City of Detroit  
**City Engineering Division, Department of Public Works  
Survey Bureau**

NOTICE OF PROPOSED CHANGE IN PROPERTY

Petition: x437 ✓

REQUEST TO VACATE  
 A PORTION OF ALEXANDRINE AVE., 17 FT. WD.  
 AND A PORTION OF SECOND AVE., 10 FT. WD.  
 IN THE BLOCK BOUND BY  
 SECOND, WILLIS, CASS  
 AND ALEXANDRINE AVE.

CITY OF DETROIT CITY ENGINEERING DEPARTMENT SURVEY BUREAU	
JOB NO.	01-01
DRWG. NO.	X 437

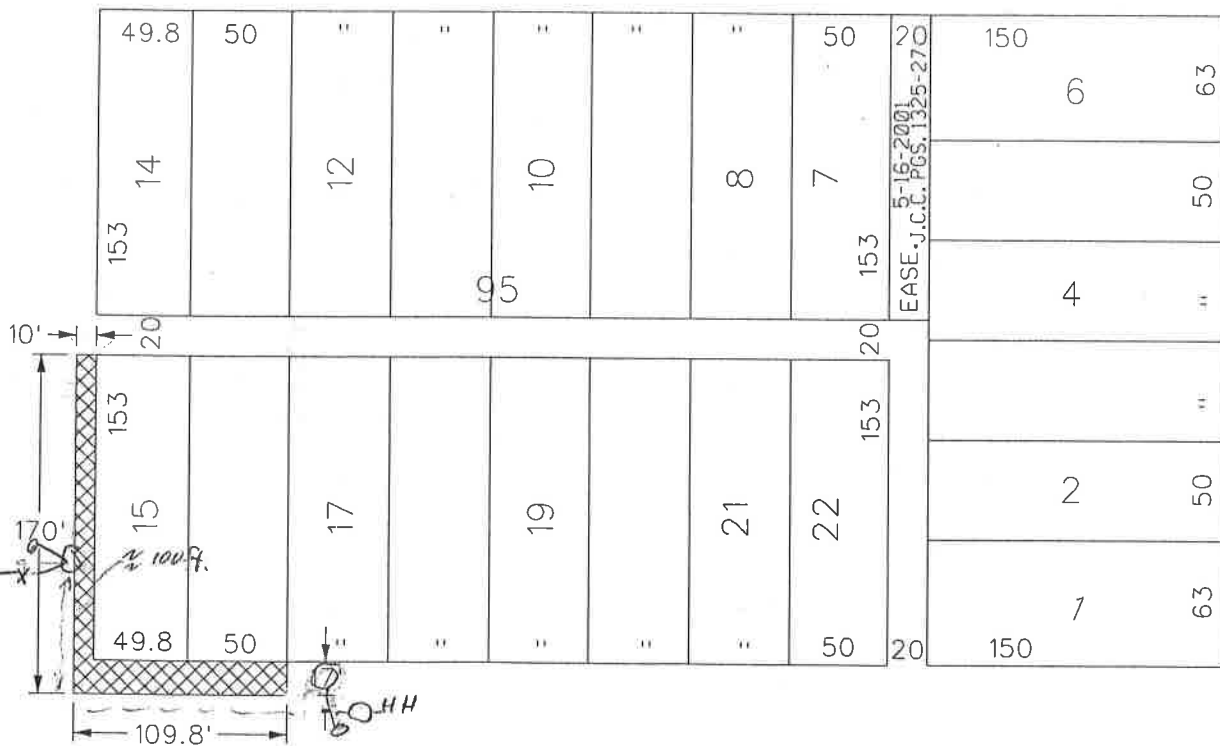
After a review of the paper work, we have revised our response to indicate "Not Involved".

It appears that the PLD light pole on Second Ave. is not in the portion to be vacated. The property line is undefined in the field, so measurement was taken from the building front. (The pole is located 15 feet from the building front.) If our assumption is incorrect, please tell us.
